## ANN ARBOR HISTORIC DISTRICT COMMISSION

### Staff Report

**ADDRESS:** 210-216 S Fourth Avenue, Application Number HDC 13-133

**APPLICATION:** The applicant seeks HDC approval to (1) reconfigure the existing façade so that it resembles the previous Montgomery Ward façade, and (2) construct three additional floors.

**Third Floor Plan  
Montgomery Building**

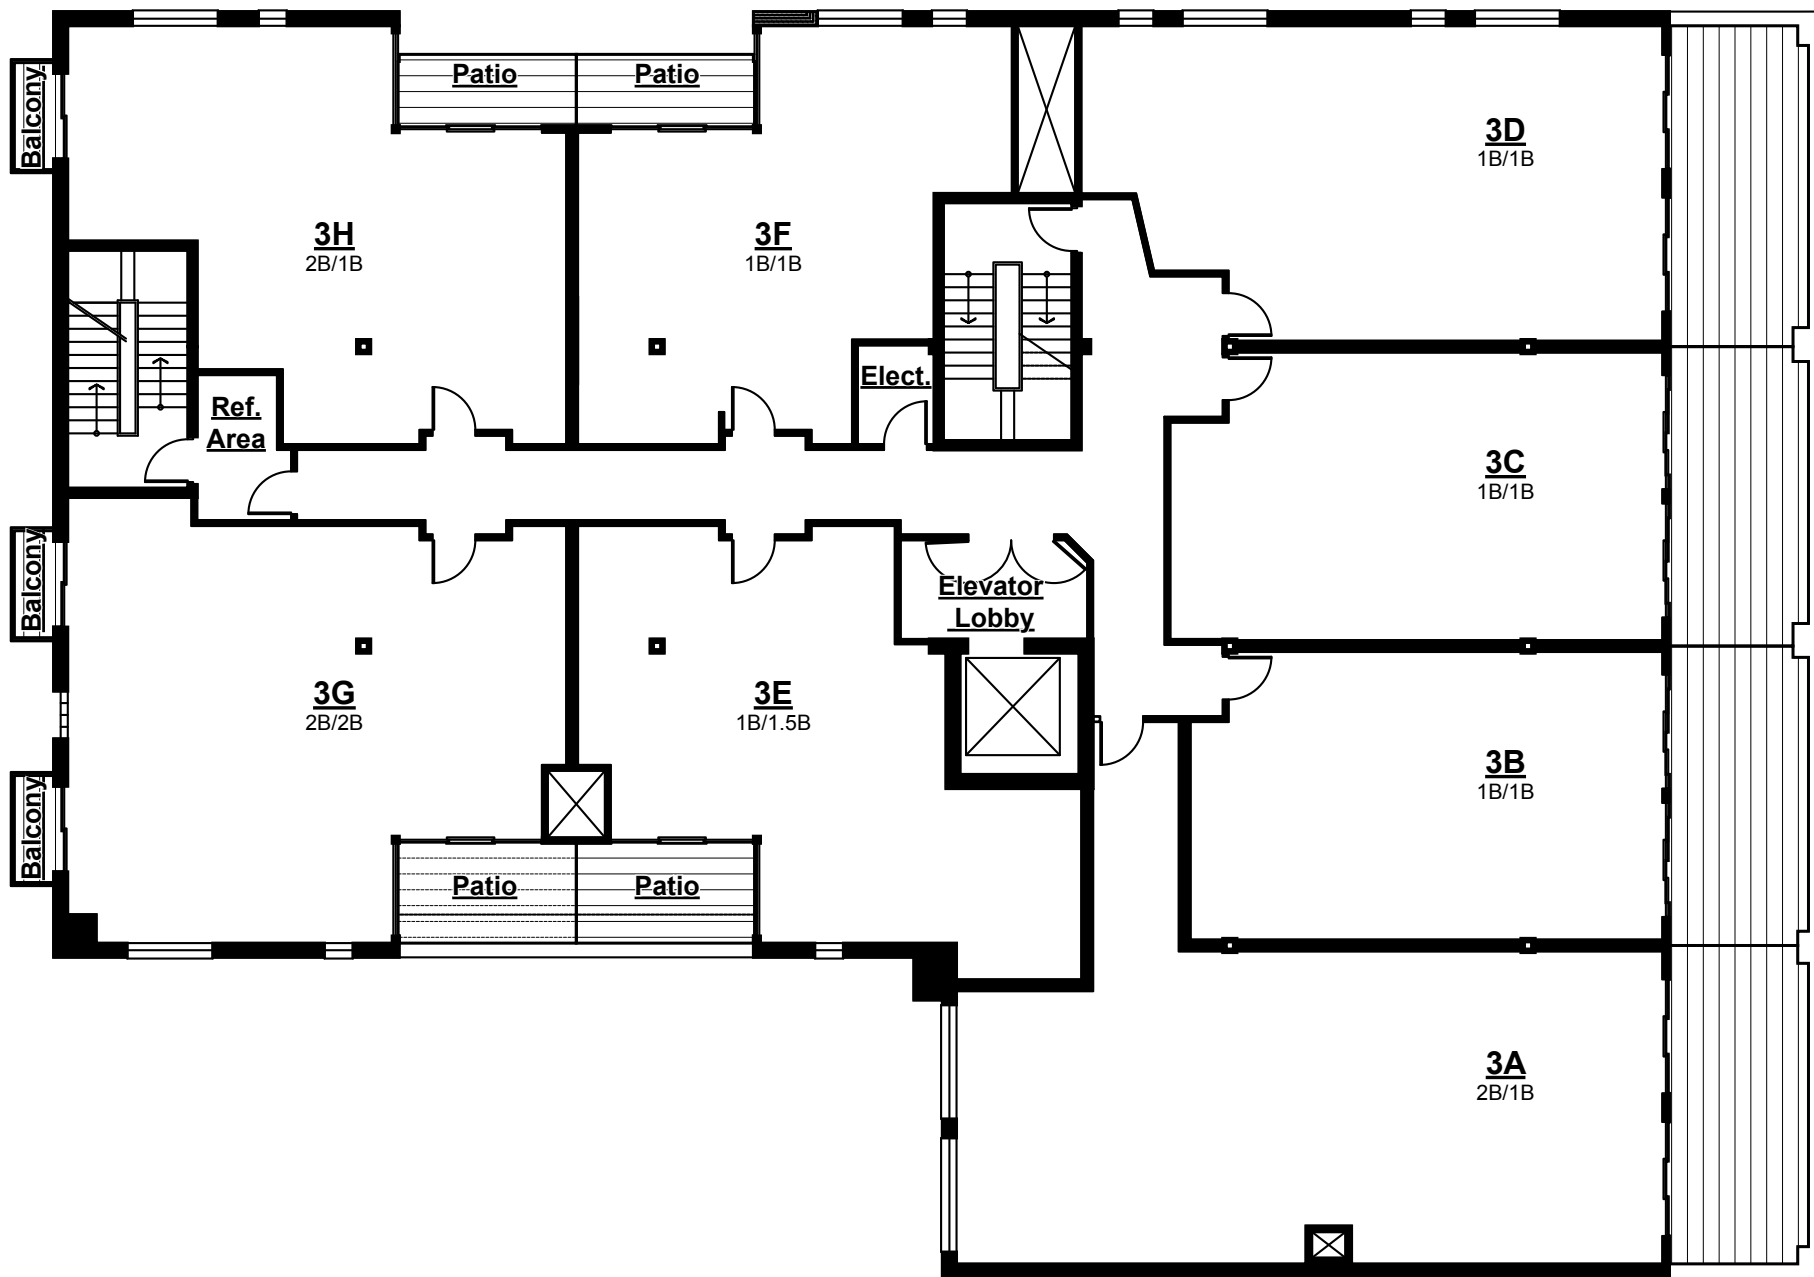
4. *Additional floors.* Per the application, the third floor would be set back nine feet from the front façade of the building, and the fourth and fifth floors would be set back an additional eleven feet. (The floor plan on page 12, however, shows these flipped -- the third floor is setback 11 feet and the fourth/fifth are an additional 9 feet.) Materials on

**4th Avenue Section**

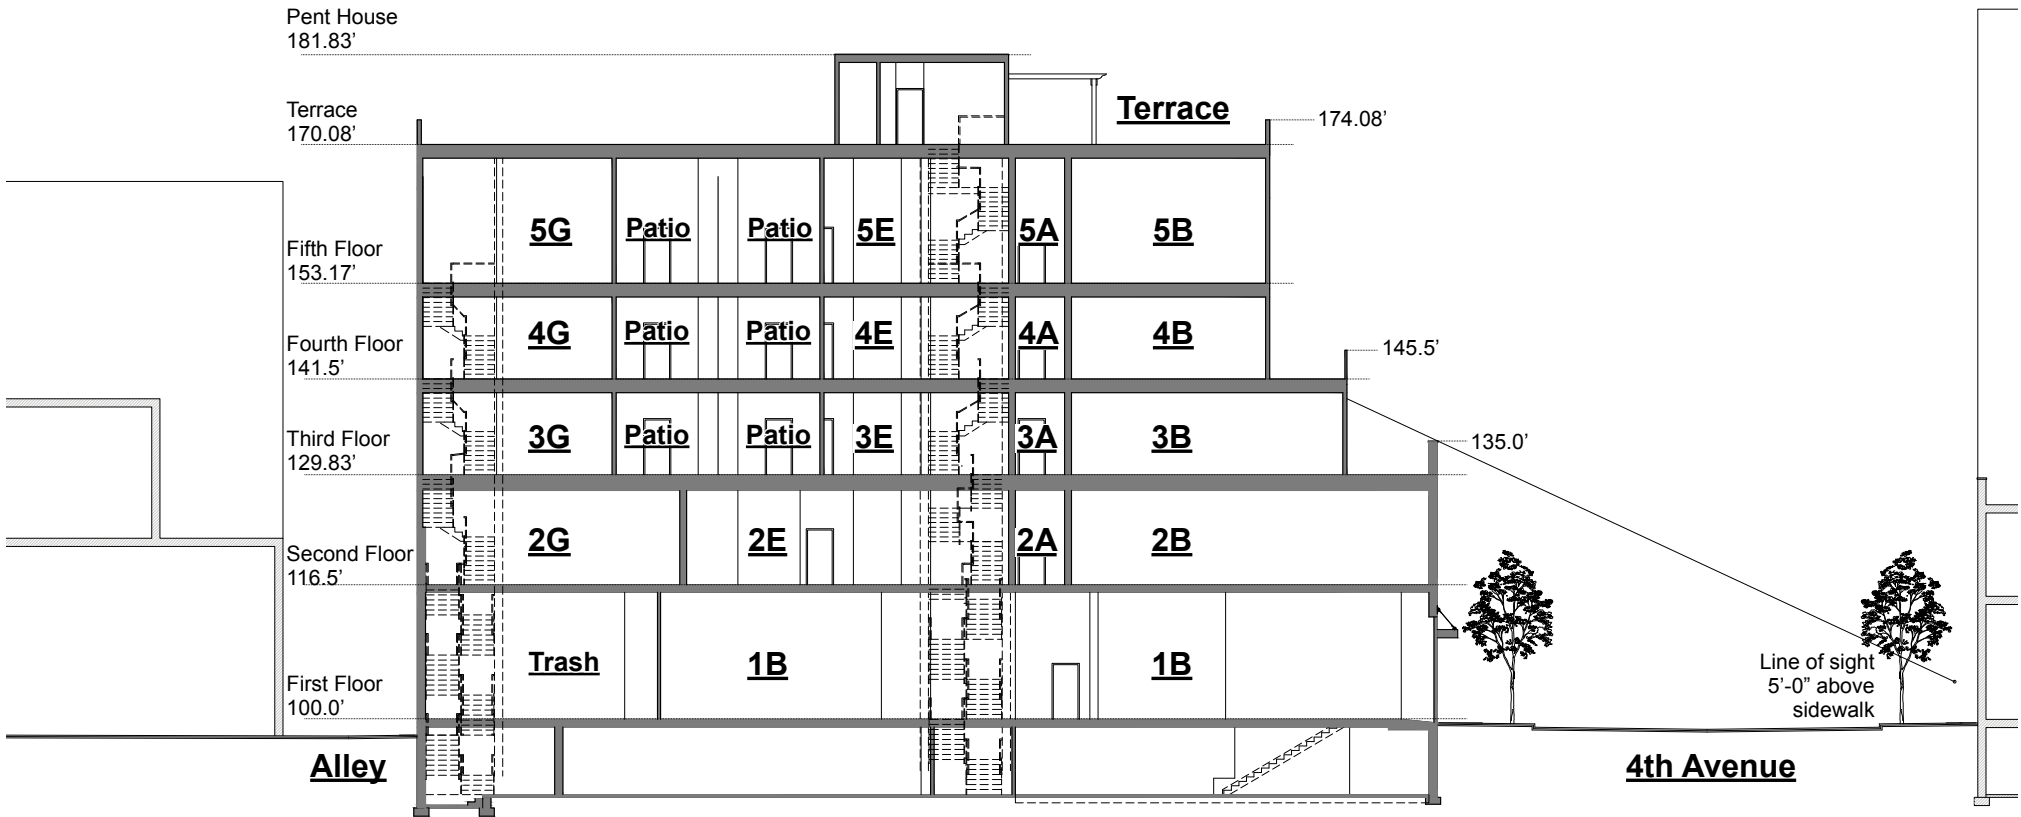
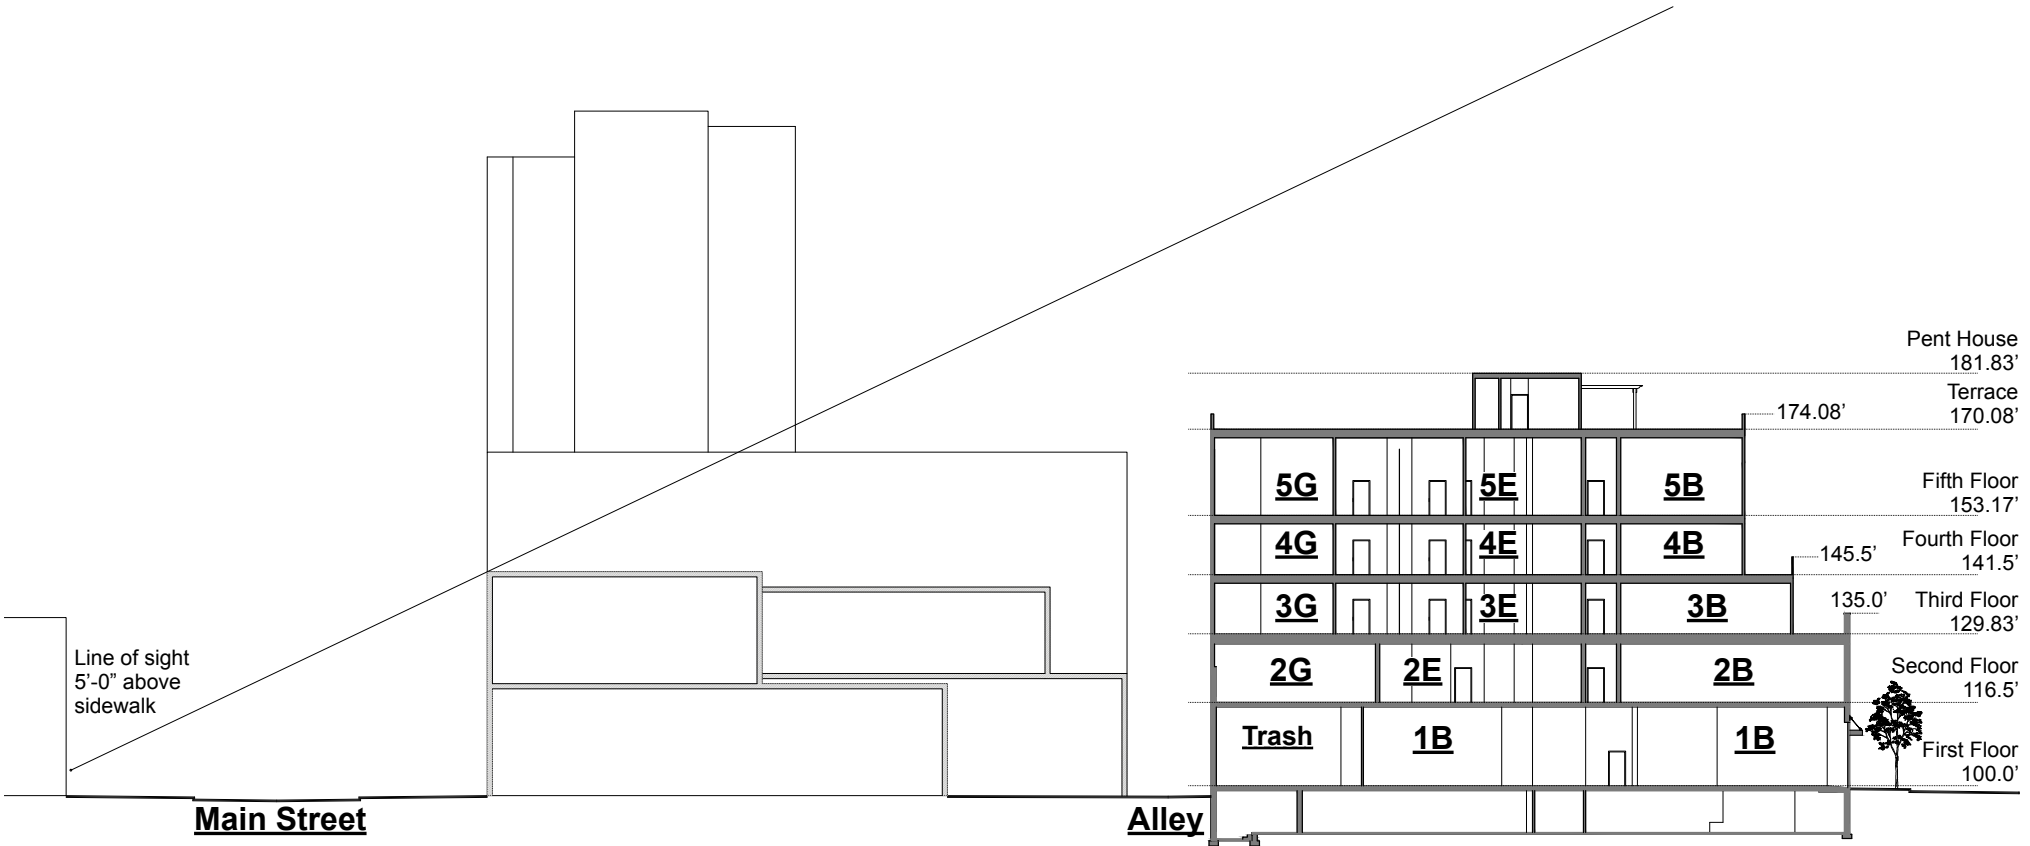
Section drawings with pedestrian sight-lines are provided on pages 15 and 16. They indicate that a pedestrian directly across South Fourth Avenue would have a view of the fourth and fifth floors, and that pedestrians on the west side of South Main Street would not see the project at all. The building will be visible from other vantage points, however, such as over the two-story buildings on East Liberty that are between Running Fit and the alley, and especially along the east side of South Fourth Avenue approaching East Washington Street, on the same block as the project. A 3-D rendering of the building from different pedestrian vantage points would help staff and the commission understand those relationships.
